**From:** Scala, Mary Joy  
**Sent:** Thursday, March 23, 2017 10:21 AM  
**To:** 'Clark Gathright'  
**Subject:** BAR Action- 617 Park Street - March 21, 2017

**RE: Certificate of Appropriateness Application**  
BAR 17-03-02  
617 Park Street  
Tax Parcel 520186000  
Megan and Chris Long, owner/ Clark Gathright, applicant  
New Driveway and landscaping

**CITY OF CHARLOTTESVILLE  
BOARD OF ARCHITECTURAL REVIEW  
STAFF REPORT  
March 21, 2017**

# 617 Park St. Driveway

**1 SITE PLAN**  
**C-1.2 SCALE: 1" = 10'-0"**

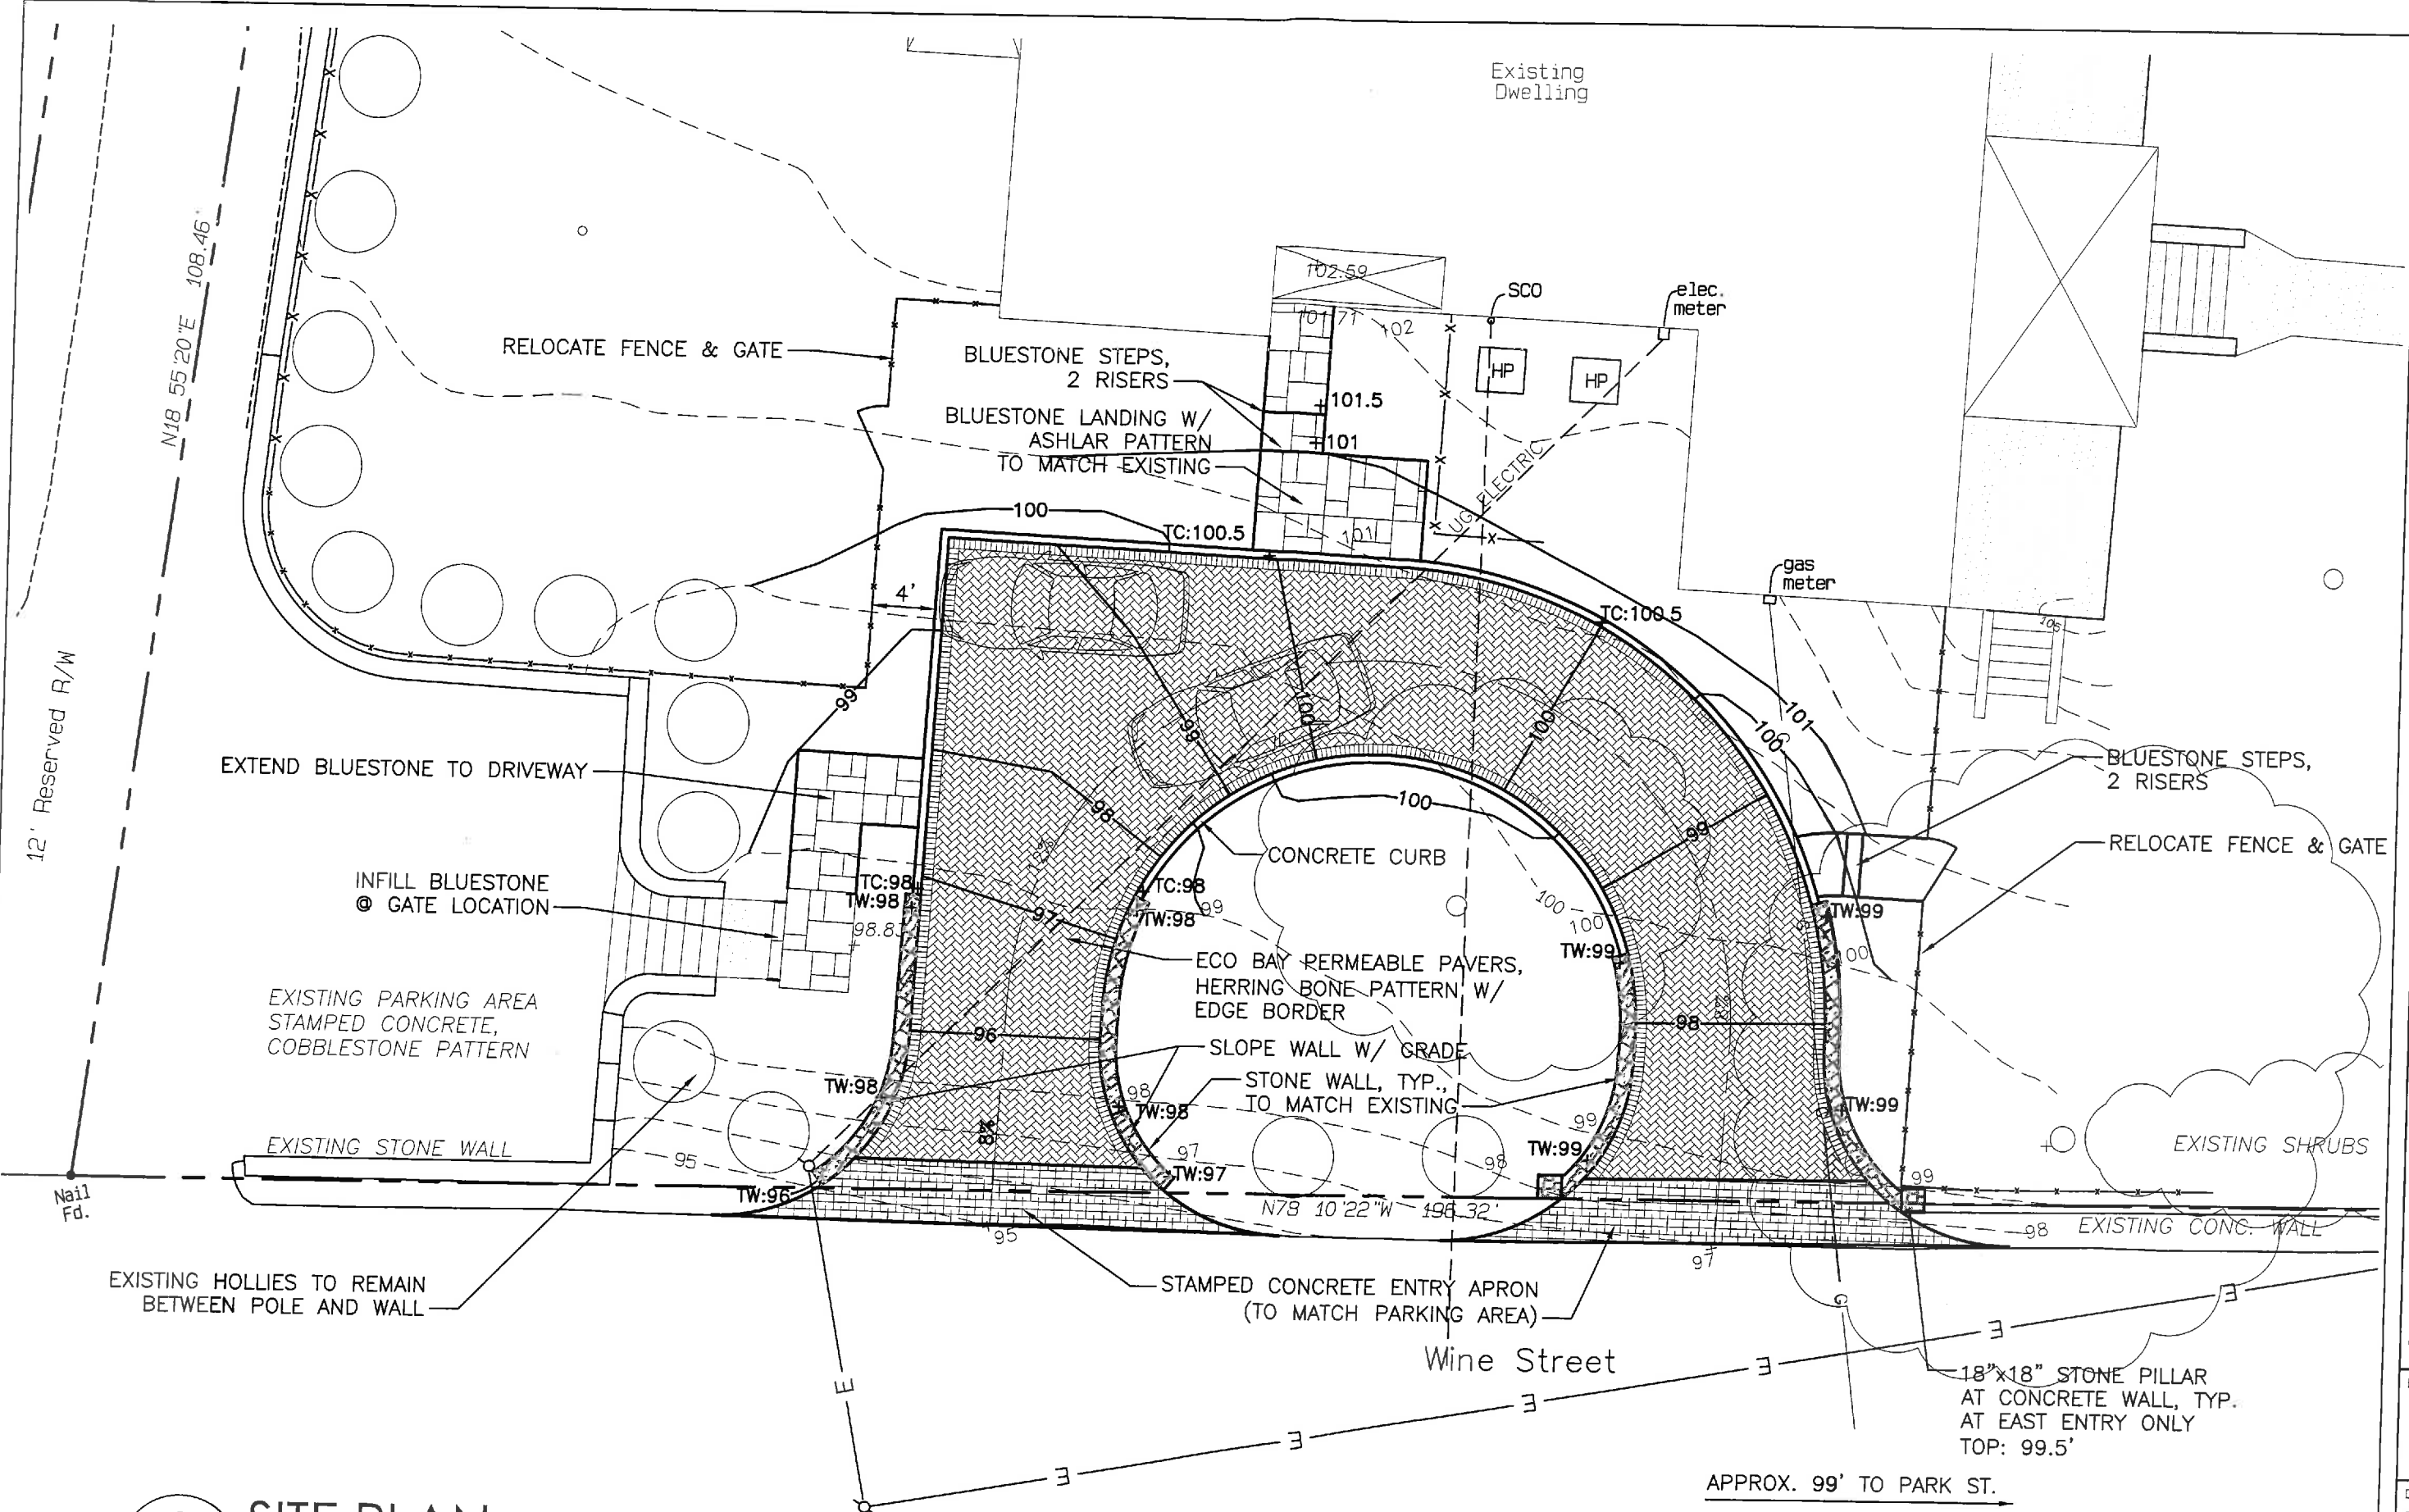
Some comments were: the choice of materials is generally appropriate without the stamped concrete; concerns about the amount of paving and number of entrances; concerns about making the side yard into a front entrance; consider screening the mechanical; encourage detailing to be consistent; suggest a car courtyard with single entrance instead of circular drive.

One guideline recommends against stamped concrete, which is shown on the driveway aprons and is intended to match the existing driveway. In staff opinion the proposed changes are appropriate.
